11-IEP-1C

RE: Comments on CEC's Estimates of Energy Efficiency in the Demand Forecast

ATTACHMENT A: KEY ISSUES AND CONCERNS REGARDING CEC DEMAND FORECAST

Figure 1. Energy Efficiency/Conservation Consumption Savings³ (2005 CEC Publication)

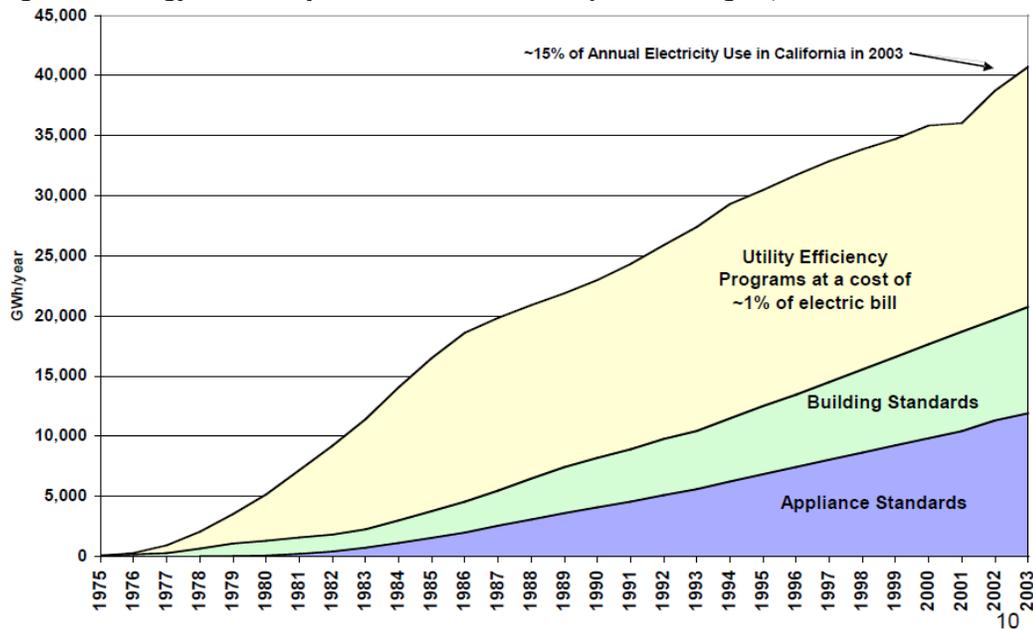
- Energy efficiency savings attributed to efficiency programs were drastically reduced between the 2005 and 2009 CEC IEPR reports (see Attachment A for further background) without a clear explanation of the methodology used to arrive at these radically different figures.

For reference, below are the 2005 and 2009 CEC publications of historical program savings. Figure 1 depicts the graph that was used for the years leading up to IEPR 2009. The figure does not disaggregate naturally occurring savings from efficiency programs. These numbers are consistent with estimates from our Northwest counterparts, who have shared similar commitments to efficiency programs and codes and standards work over the decades, as depicted by Figure 2.

Figure 2: Pacific Northwest Annual Energy Efficiency Achievements⁴

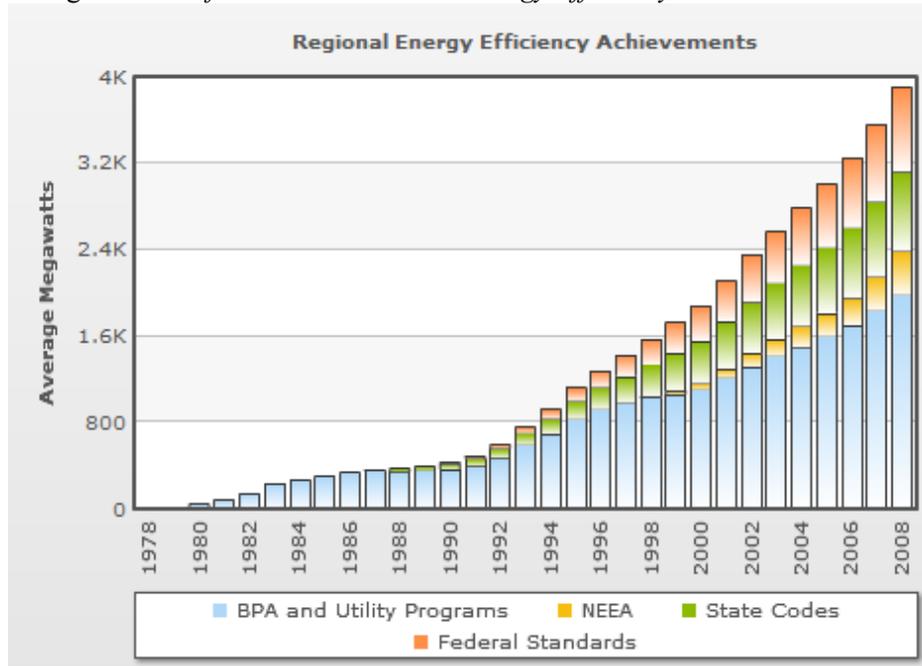
In Figure 2, the Northwest Energy Conservation Council (NECC) attributes regional energy efficiency achievements to various categories. In comparing these two charts, California utilities were credited with contributing 42% of total savings while the northwest utilities were credited with contributing about 50% of total savings in Figure 2. The similarity in results seems reasonable given the similar shared commitment to and history of energy efficiency programs.

Figure 3 Energy Efficiency/Conservation Consumption Savings (2009 CEC Publication)⁵

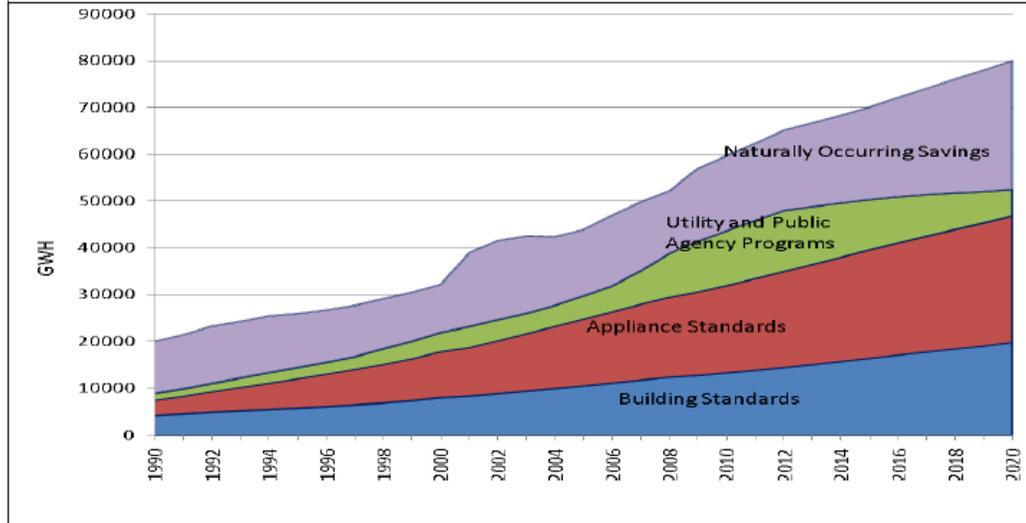
- The revised graphical depiction of the sources of energy savings, which previously showed roughly equal wedges for historic savings from utility programs and codes and standards, is highly misleading in its seeming replacement of the majority of the utility program savings wedge with “naturally occurring savings.” This change from previous depictions of this graph stands to be extremely confusing to the public, both inside and outside of California. The more recent graph does not promote confidence in the relative contribution of each source of efficiency savings, while both are essential components of California’s energy efficiency policy.

Ultimately, the Efficiency Council is very concerned about the underlying message, or perceived message, of the most recent CEC graph of historical energy efficiency impacts. Without further explanation of what “naturally occurring savings” may mean, the graph risks implying to the casual observer that a laissez-faire approach to energy efficiency, in which efficiency programs are unnecessary, is significantly more effectual than sustained investment in efficiency programs to overcome market barriers to wide-spread adoption of energy efficiency. This argument is diametrically opposed to an abundance of academic literature that describes the various market failures associated with energy efficiency, and the need for policy and program invention to address them.¹ In addition, the conclusion that efficiency programs are unnecessary, which some may reach after seeing the revised graph, is contrary to the experiences of our member companies who have found their programs to be successful in motivating customers to make energy efficiency improvements and providing substantial energy and bill savings to those customers.

Thus, it is disconcerting that the CEC’s revised graph released in the 2009 CEC Demand Forecast publication would radically diverge from these results, as depicted in Figure 3. Here, the graph reflects savings attributed to a new category of savings due to naturally occurring causes, which is implied to be mutually exclusive to the original categories but also seems to drastically reduce utility program contributions.

- The Efficiency Council recommends that the Commission consider presenting a single total estimate of energy savings produced from the Demand Forecast model, since the current model may not be well suited to identify and parse the causes (utility programs versus price effects versus standards) associated with these savings categories. The Efficiency Council strongly supports the staff recommendation to present a sum of the total historical savings from all categories.²
- However, if the CEC wishes to present a parsed energy efficiency savings impact graph by type of savings as the staff also recommends, the Efficiency Council recommends that the CEC do so in a highly transparent and clear manner within the report. We recommend that the Commission provide confidence intervals for these individual savings estimates and acknowledge key methodological issues,

- The final demand forecast should utilize a single total estimate of energy savings since the current model is not suited to identify and parse the causes associated with savings.
- If the CEC does attempt to include the parsed energy-efficiency savings graph, it should be done in a highly transparent manner. The CEC should provide confidence intervals for their estimates and acknowledge issues like the discrepancy in results based on what the model inputs first, and as well as price and program entanglement effects.
- Conduct sensitivity analyses on the most uncertain factors associated with both the savings from energy efficiency and the demand forecast to assess the magnitude of the impact on model results. At a minimum, we suggest the CEC assess sensitivity to price elasticity market and utility program entanglement.

Figure 4. Difference in Distribution of Savings

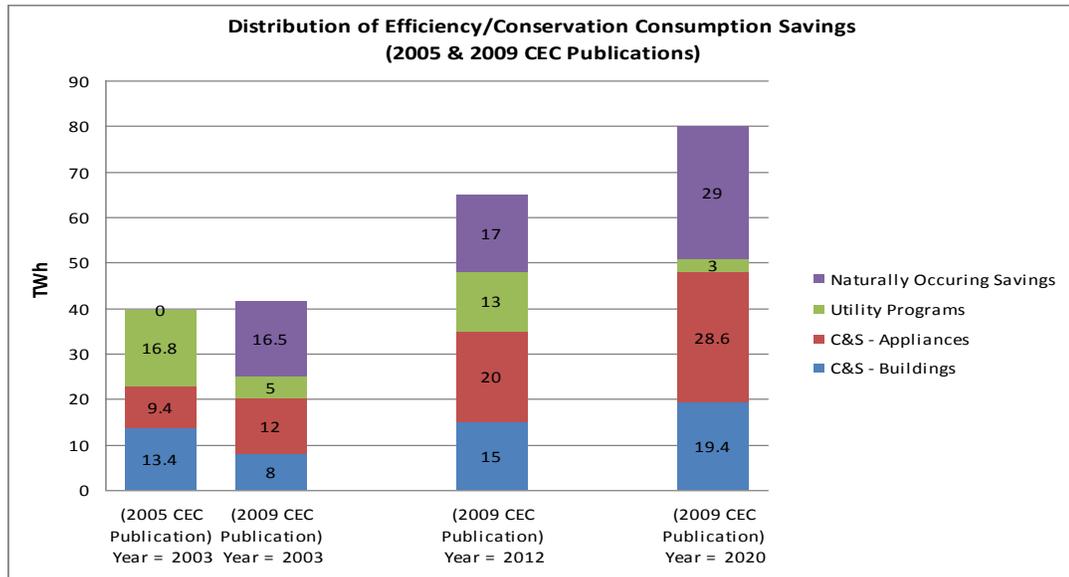
Figure 4 captures the dramatic reduction in both historic and future programmatic savings. In comparing the 2005 and 2009 CEC publications for the year 2003, one can see that **savings attributed to efficiency programs decreased from 42% of the total to just 12% of the total; this is a 75% reduction in savings attributed to programs**. Likewise, projections from the 2009 publication reduce program impacts down to just 4% of the total in 2020, while naturally occurring savings account for 36% of the total.
